### **REMARKS/ARGUMENTS**

**AMENDMENTS TO THE DRAWINGS**

Fig. 3

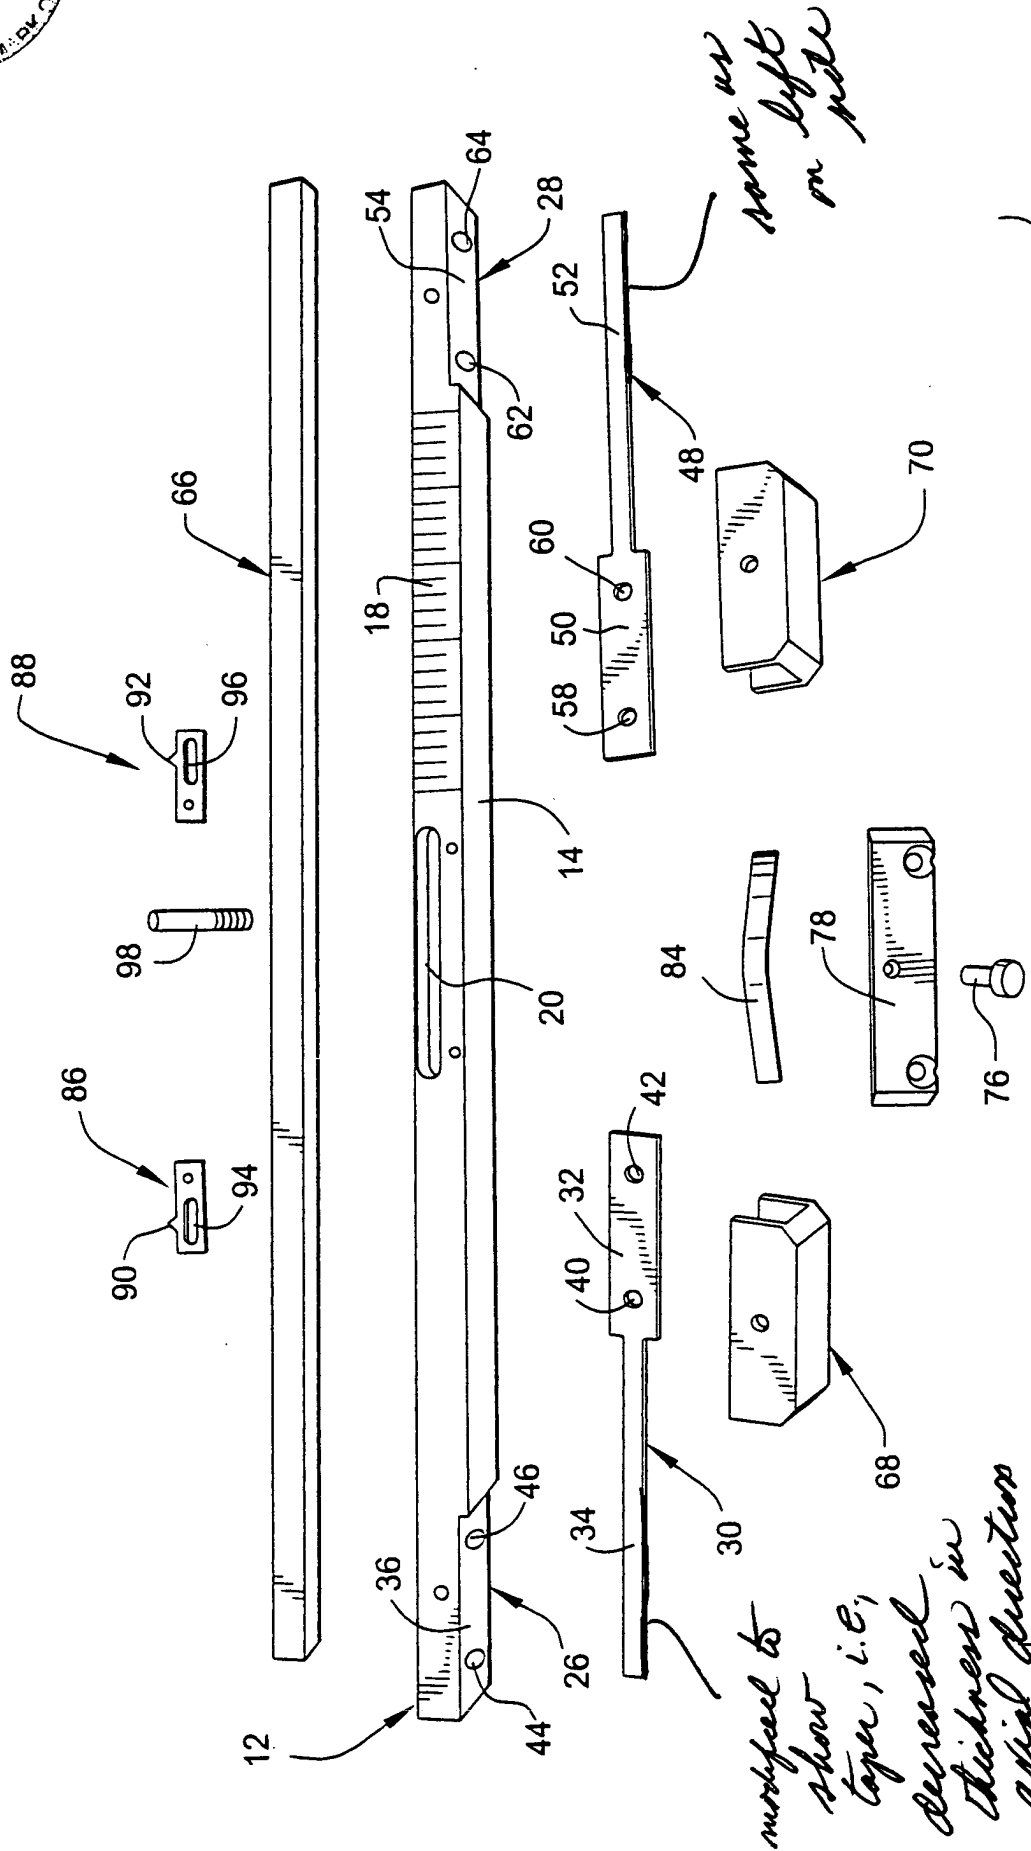
The Examiner has objected to the drawings for failure to indicate that the feeler gages are taped.

The Examiner's attention is to Figures 1 and 2 where it is apparent that the feeler gages 34 and 52 taper in thickness in the axial direction. The Examiner will appreciate that because of the drawing scale, it is difficult to clearly illustrate a significant taper. In any event, and in order to make Figure 3 consistent with Figures 1 and 2, applicant proposes to amend the feeler gages 34 and 52 in Figure 3 to also reflect a taper in the axial direction. That there is such a taper is readily apparent and fully supported in paragraph 22 on page 8 where it is stated that:

Applicant proposes to amend Figure 3 as marked on red on the attached of original Figure 3.

This description along with the clear understanding in the art of exactly what a "tapered feeler gage" is understood to include (and, of course, given the taper shown in Figures 1 and 2), establish that the amendment to Figure 3 does not involve the introduction of any new matter.
